Project	IEEE 802.16 Broadband Wireless Access Working Group < http://ieee802.org/16 >	
Title	Comments on MS Initial Ranging with Non-transparent RS (Centralized)	
Date Submitted	2007-07-16	
Source(s)	Kanchei (Ken) Loa, Yi-Hsueh Tsai, Yung-Ting Lee, Hua-Chiang Yin, Shiann-Tsong Sheu, Youn-Tai Lee, Institute for Information Industry 8F, No. 218, Sec. 2, Dunhua S. Rd., Taipei City 106, Taiwan Masato Okuda Fujitsu	Voice: +886-2-27399616 Fax: +886-2-23782328 loa@nmi.iii.org.tw okuda@jp.fujitsu.com
Re:	IEEE 802.16j-07/019: "Call for Technical Comments Regarding IEEE Project 802.16j"	
Abstract	This contribution proposes modifications for MS Initial Ranging with Non-transparent RS	
Purpose	Text proposal for 802.16j Baseline Document.	
Notice	<i>This document does not represent the agreed views of the IEEE 802.16 Working Group or any of its subgroups. It represents only the views of the participants listed in the "Source(s)" field above. It is offered as a basis for discussion. It is not binding on the contributor(s), who reserve(s) the right to add, amend or withdraw material contained herein.</i>

Comments on MS Initial Ranging with Non-transparent RS (Centralized)

Figure 1 MS network entry procedures

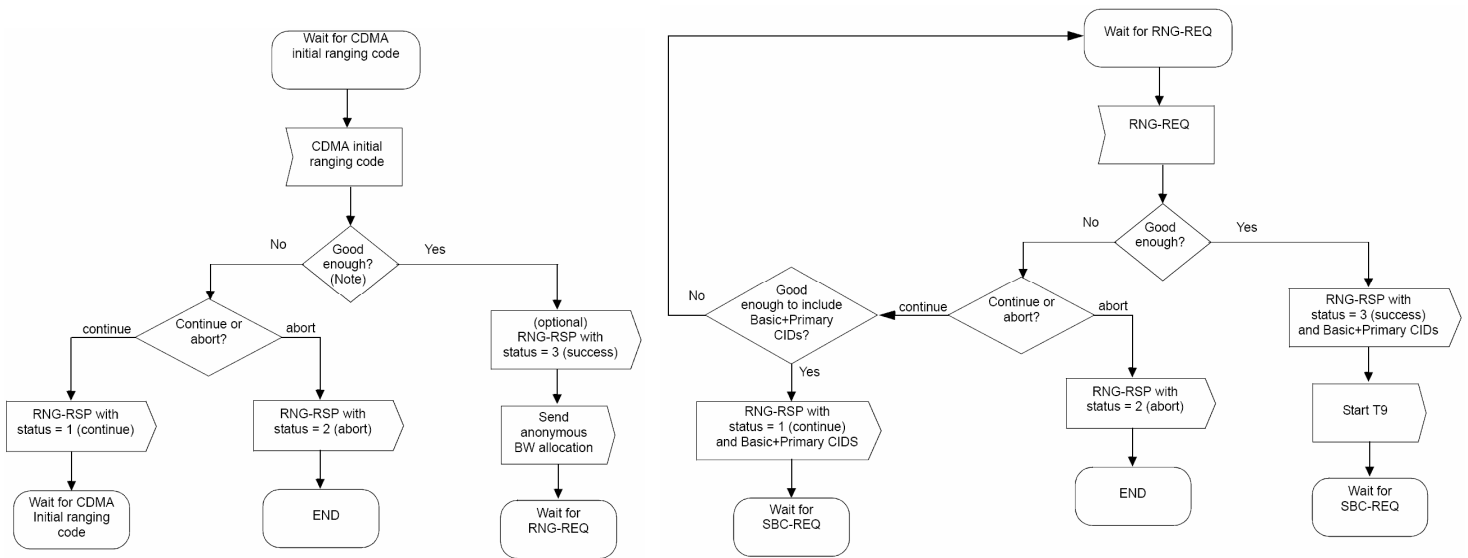
In the current baseline document 802.16j-06_26r4, RS transmits a RNG-REQ to the MR-BS after receiving the CDMA code that requires no corrections is to request MR-BS to generate the CDMA_Allocation IE() for MS. Therefore, we propose to simplify the procedure for MS initial ranging with non-transparent RS by having RS locally sending a RNG_RSP message to the MS on the access link. As a result, the RS utilizes the same procedure to handle the received CDMA code resulting in the success status or continue status. Moreover, in **P80216Rev2_D0b**, it defines “*When the BS receives an initial-ranging CDMA code that requires no corrections, the BS shall provide BW allocation for the SS using the CDMA_Allocation_IE to send an RNG-REQ message. Sending the RNG-RSP message with status “Success” is optional*”. Thus, this contribution proposes modification, consistent with **P80216Rev2_D0b**, on MS initial ranging with non-transparent RS in section 6.3.9.16.2.1 of baseline working document IEEE 802.16j-07/026r4. The flow charts of MS network entry procedures in Corrigenda 2/Draft 4 are provided in figure 1 for reference.

Table 199b—Ranging and automatic adjustments procedure in MR mode

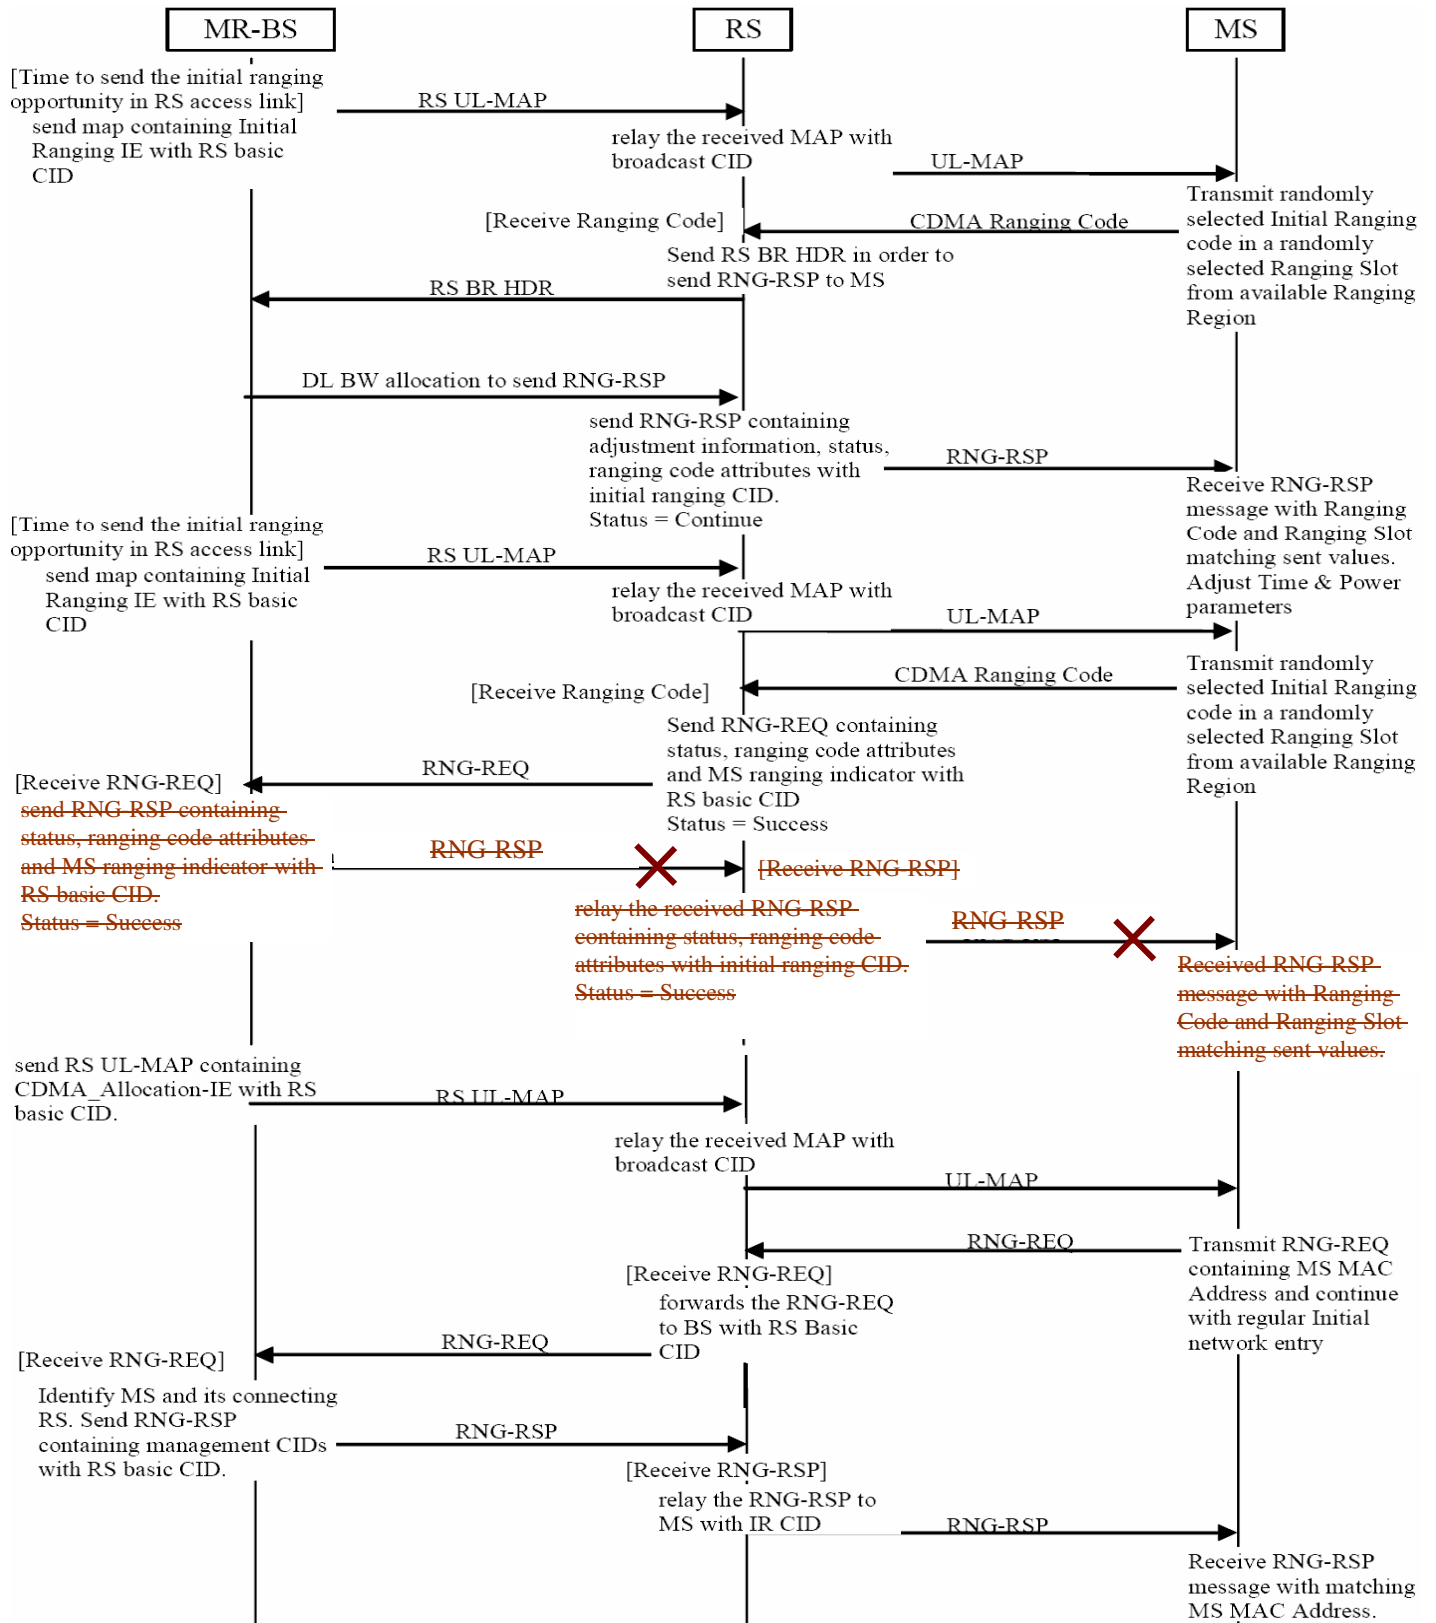
[Change the following Table 199b in page 84 as indicated]

Figure 95e Handle CDMA Initial Ranging Code at Non-transparent RS

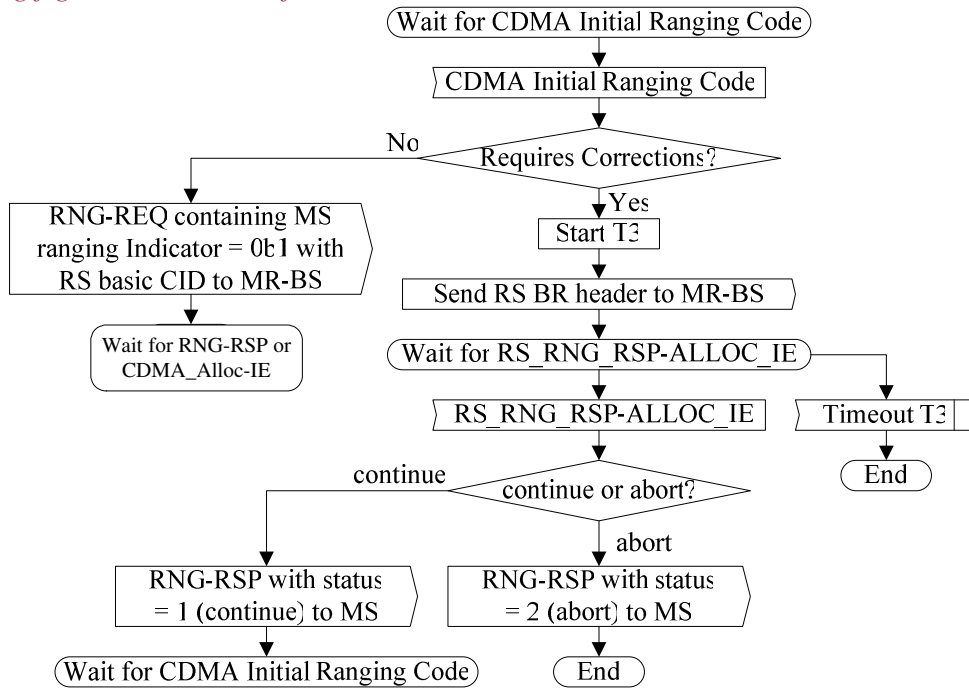
[Insert the following figures at the end of subclause 6.3.9.16.2.1:]
